Dekko Fashions Ltd Dekko Apparels Ltd

Dhaka
(23.819890, 90.363120)
1st April 2014

Observations

Escape Stair

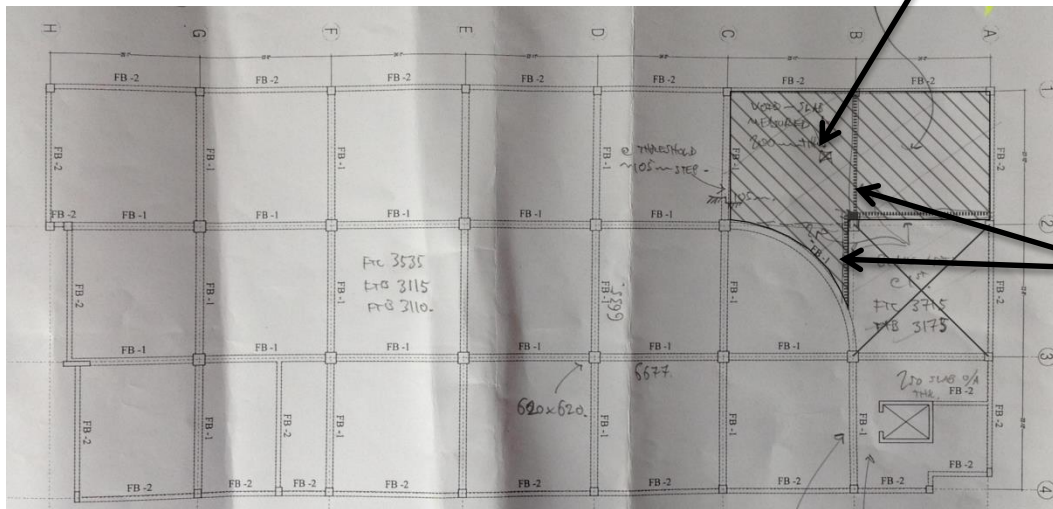
Escape stair to front elevation which appears to be 'non-engineered' due to the small size of the stair stringer members and support columns. This stair will also apply point loading to the First floor projecting roof slab: it is not clear if this structure has been checked for this additional loading.

| Item No. | Observation | Recommended Action Plan | Recommended Timeline |
|----------|--|---|----------------------|
| 1 | Apparently non-engineered steelwork to escape stairs | Building engineer to check the capacity of the steel stairs and supporting slab under fire escape loading | 6-weeks |
| 2 | Apparently non-engineered steelwork to escape stairs | Carry out any alterations required from the Assessment | 6-months |

First Floor Curved Beam

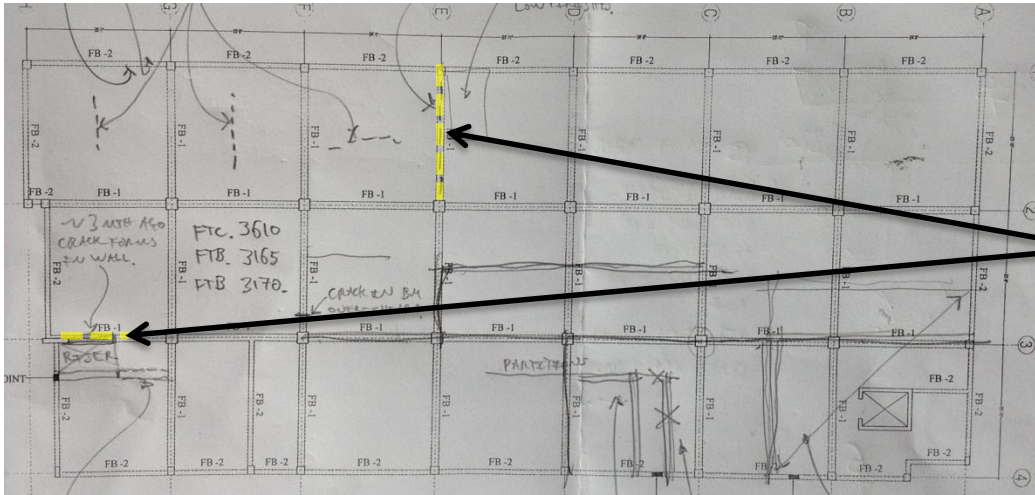
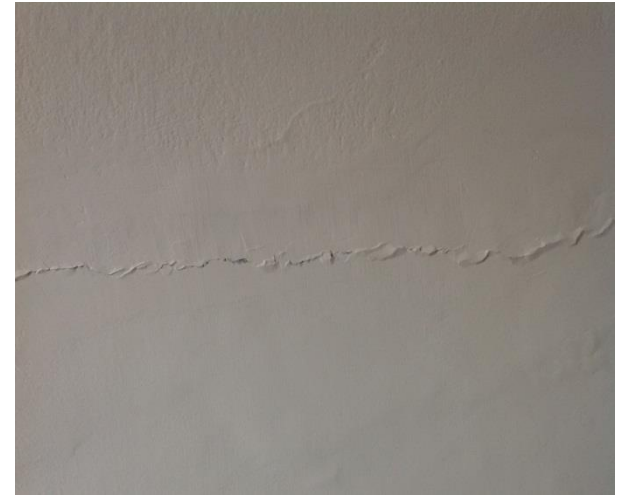
The loading on the curved beam at First floor in bay C2/B3 has increased due to the introduction of additional floor slab.

The additional slab area is marked on the plan below, which part-infills the double-height space at the front of the building.

Additional support column and beams (one of which frames into the curved beam). It is unknown if the capacity of the curved beam, nor the surrounding columns and foundations have been checked for the additional forces from the slab infill.

| Item No. | Observation | Recommended Action Plan | Recommended Timeline |
|----------|--|---|----------------------|
| 3 | Additional loading onto original curved beam due to recent infill slab | Building engineer to check the structures and provide structural drawings and loading plan for the new First floor area | 6-weeks |

Cracking in Masonry Panels at Level 6

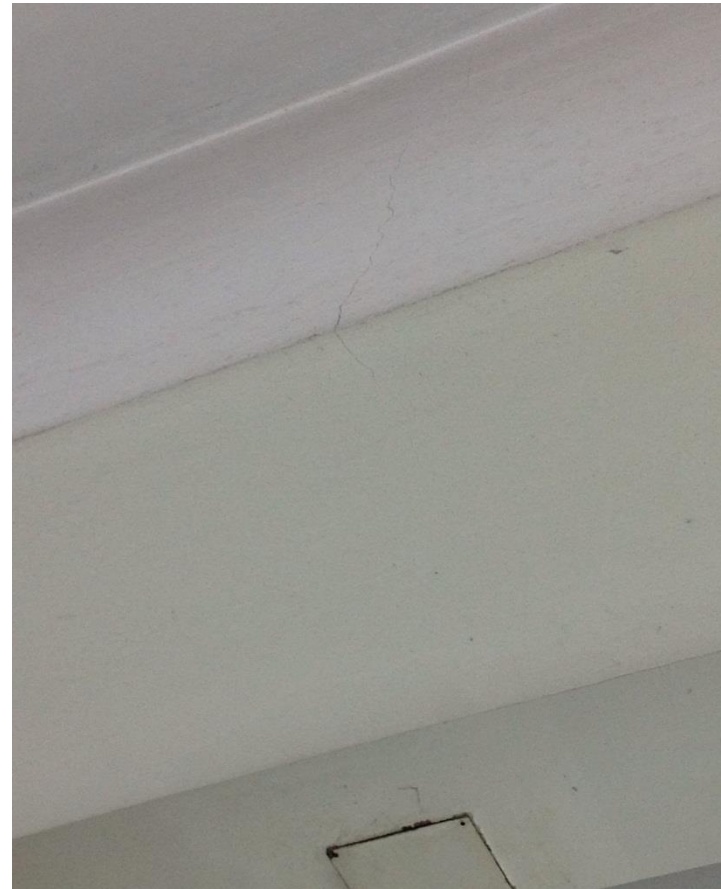
Cracking in masonry panels was observed at Level 6 to two locations as-marked.

| Item No. | Observation | Recommended Action Plan | Recommended Timeline |
|----------|--|---|----------------------|
| 4 | Cracking in masonry panels at Level 6 | Engineer to monitor the recent cracking in masonry panels at level 6. Assessment to be made following monitoring and Engineer to specify repairs and strengthening if necessary | 6-months |
